SITE PLAN (AP ZONE)
3150 BEAR STREET, COSTA MESA CA 92629

EASEMENT PLAN
3150 BEAR STREET, COSTA MESA CA 92629

BUILDING AND SAFETY (B&S): EVENT SPACE SUITE 100B USE FOR WEDDING AND CEREMONY

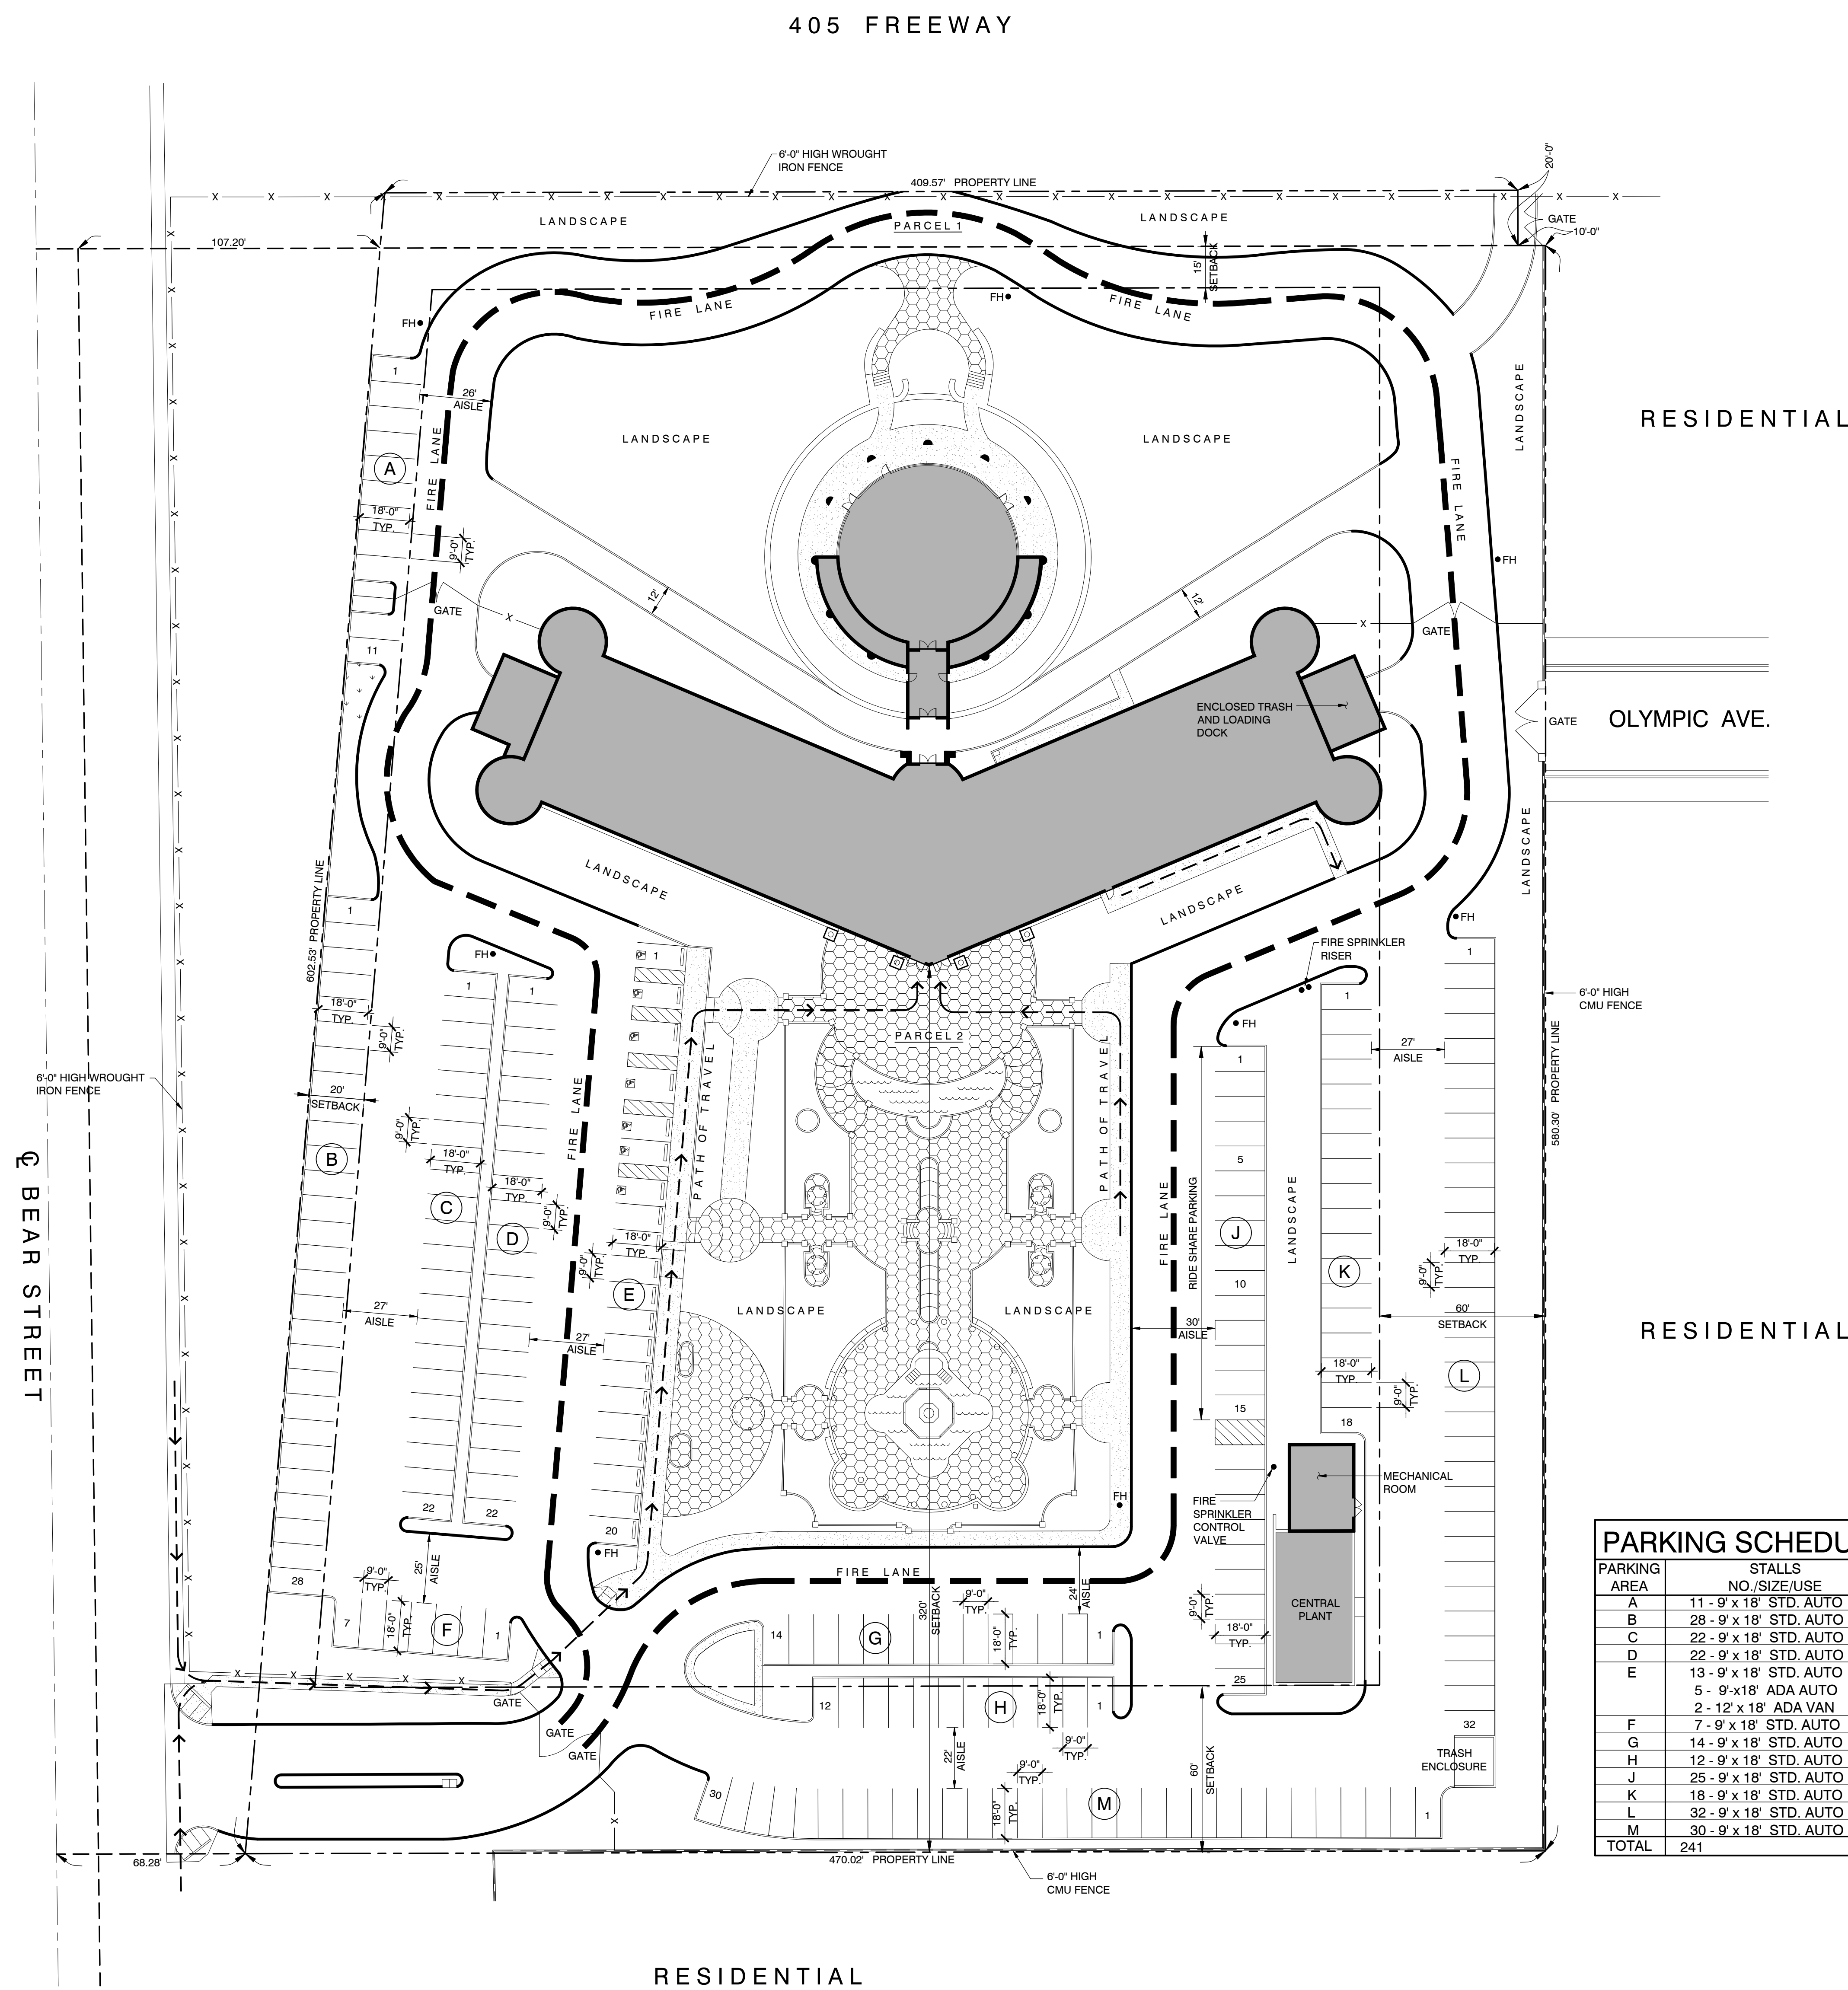
BUILDING AND SAFETY (B&S)
1. All design and construction shall comply with the latest California adopted codes.
2. All accessible parking spaces, access aisles, and path-of-travel shall be accessible for individual with disabilities.
3. Specify the Type of Construction, if the building have fire sprinkler, and existing and propose occupancy.

FIRST FLOOR PLAN
 SCALE: 3/32" = 1'-0"

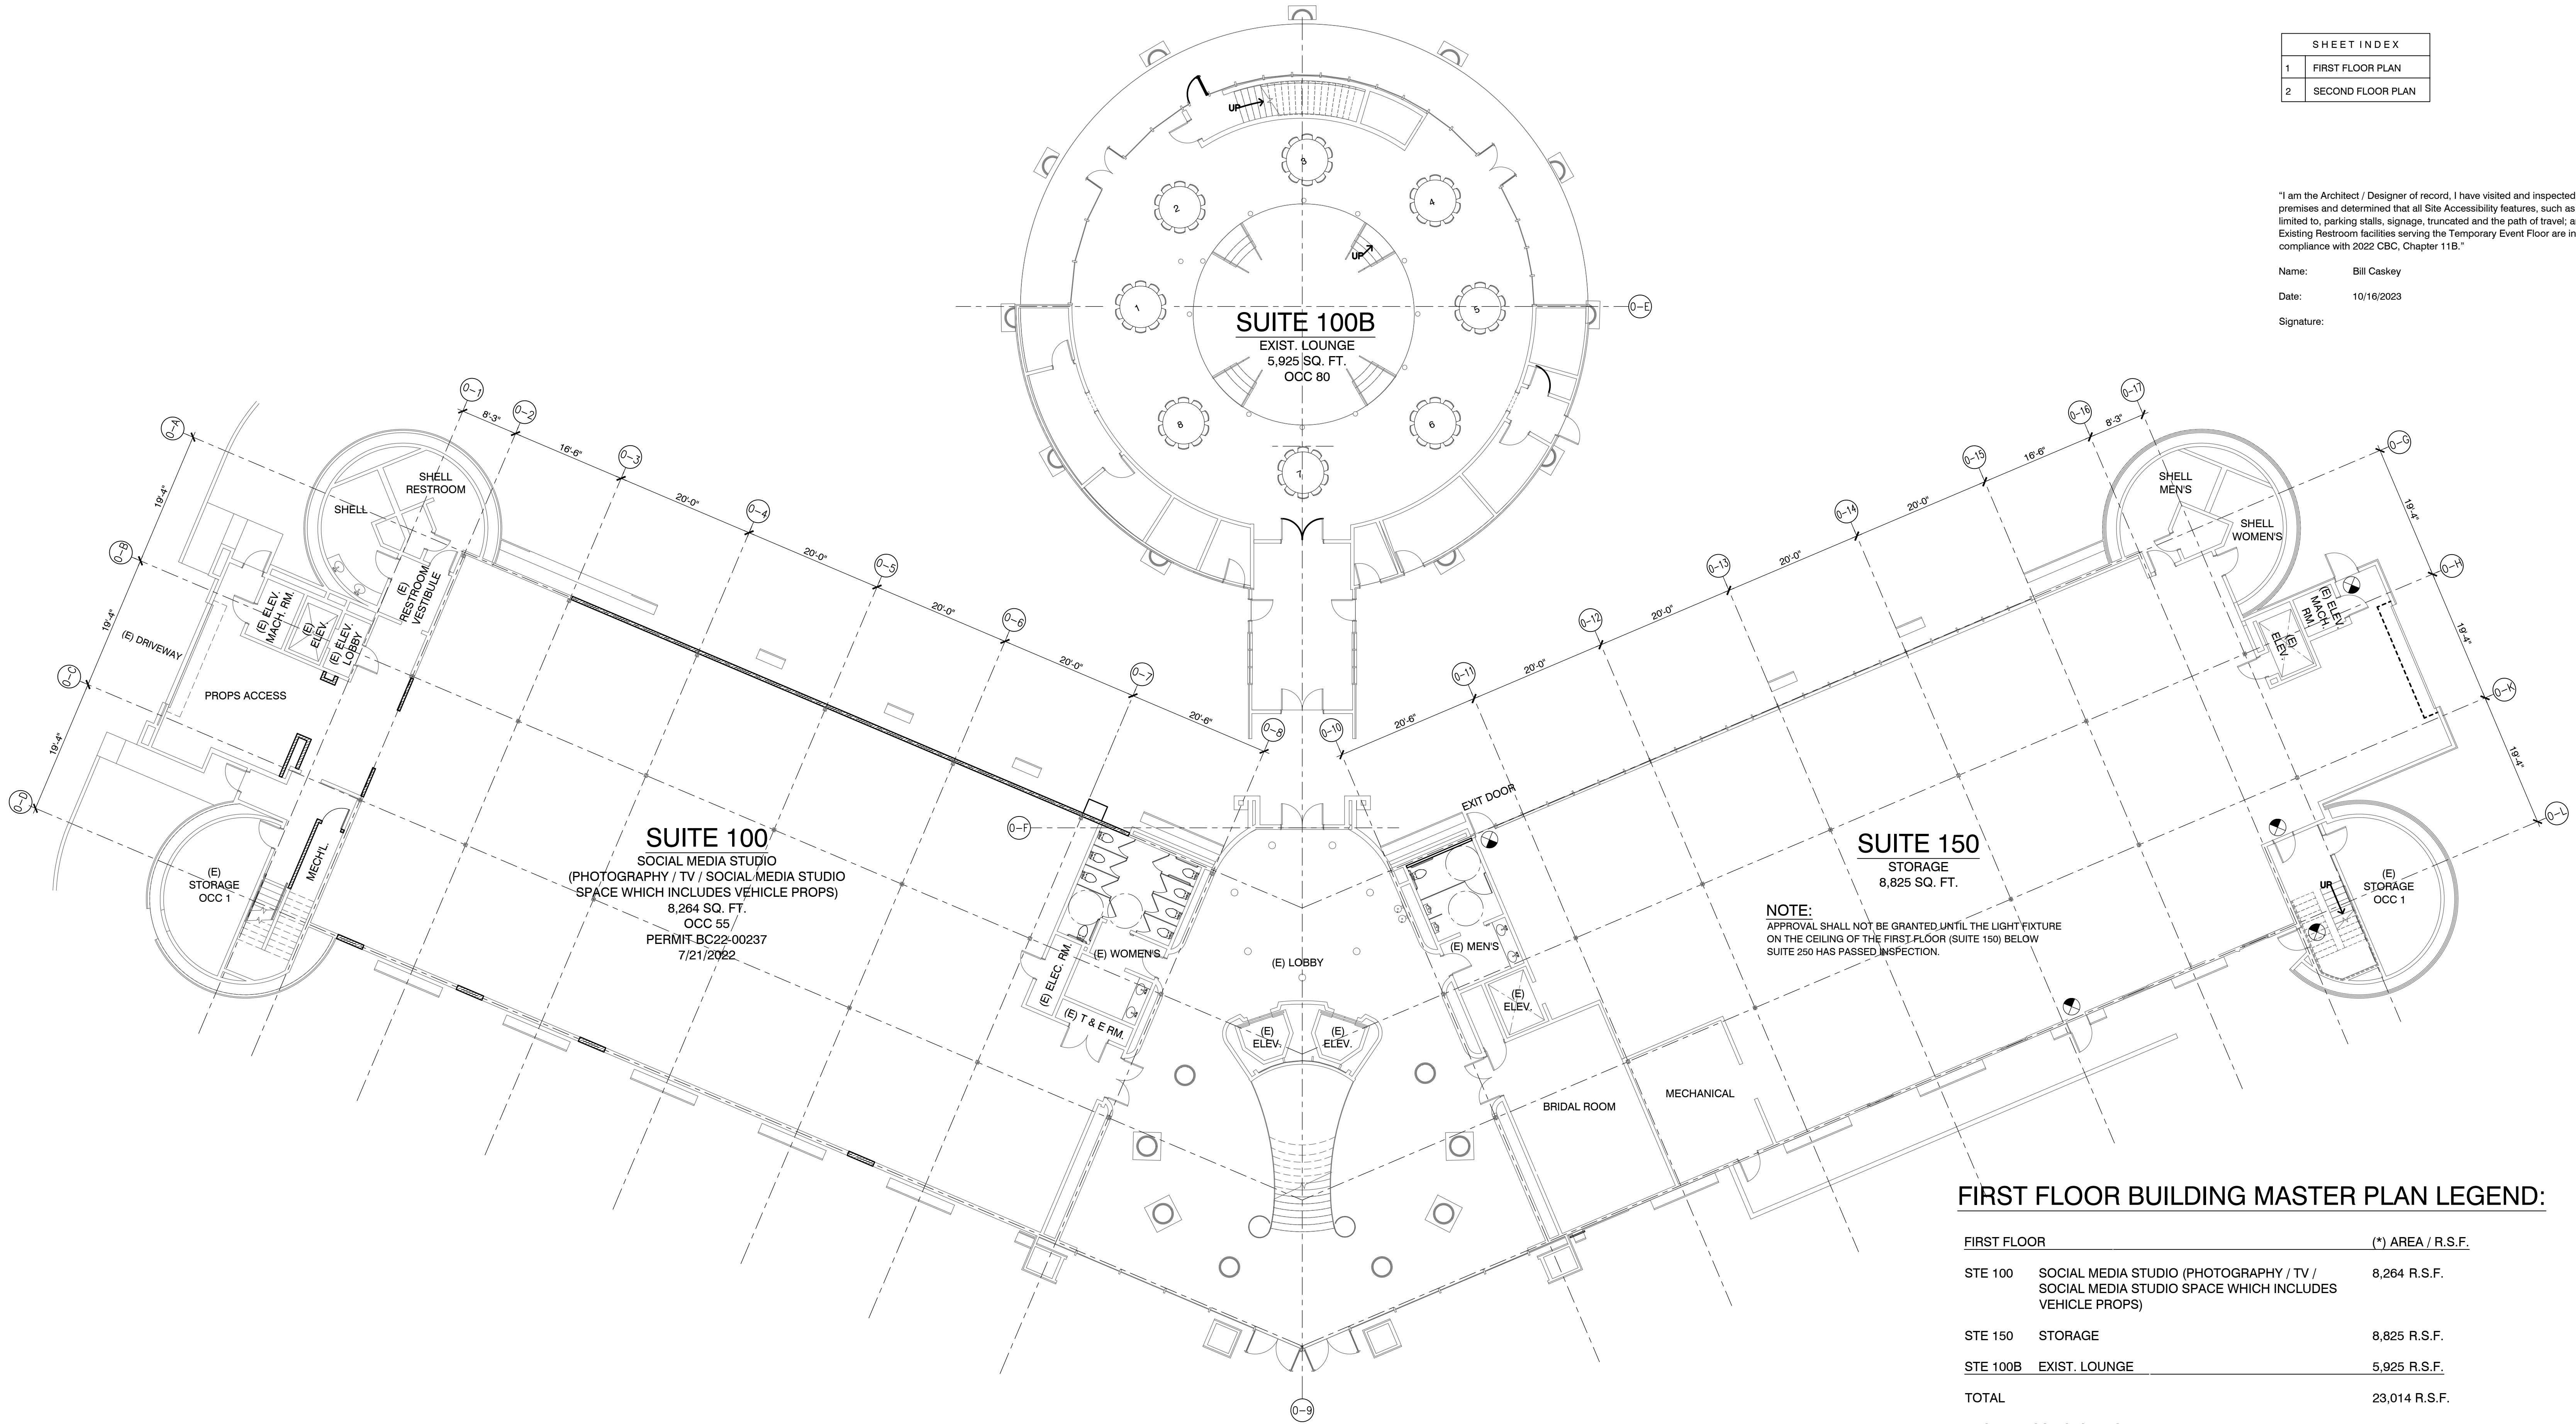
- All area of the Event Space shall be accessible for wheelchair comply with Chapter 11B. An accessible path-of-travel shall be provided from the accessible parking space to the accessible bathroom and to the event area. (CBC 11B-902.3)
- All egress from the Event Space shall comply with Chapter 10 of the CBC (the number of exits, width of the exit, travel distance, and the mean of exit).
- The occupant load for the Event Space shall be calculated using the Table 1004.5. The occupant load factor shall matches with the use closely match with the propose use of the space and shall meet the more stringent of all occupancies that are served.
- An existing floor plan demo shall be provided for plan check.

"I am the Architect / Designer of record. I have visited and inspected the premises and determined that all Site Accessibility features, such as but not limited to, parking stalls, signage, truncated and the path of travel; and the Existing Restroom facilities serving the Temporary Event Floor are in compliance with 2022 CBC, Chapter 11B."
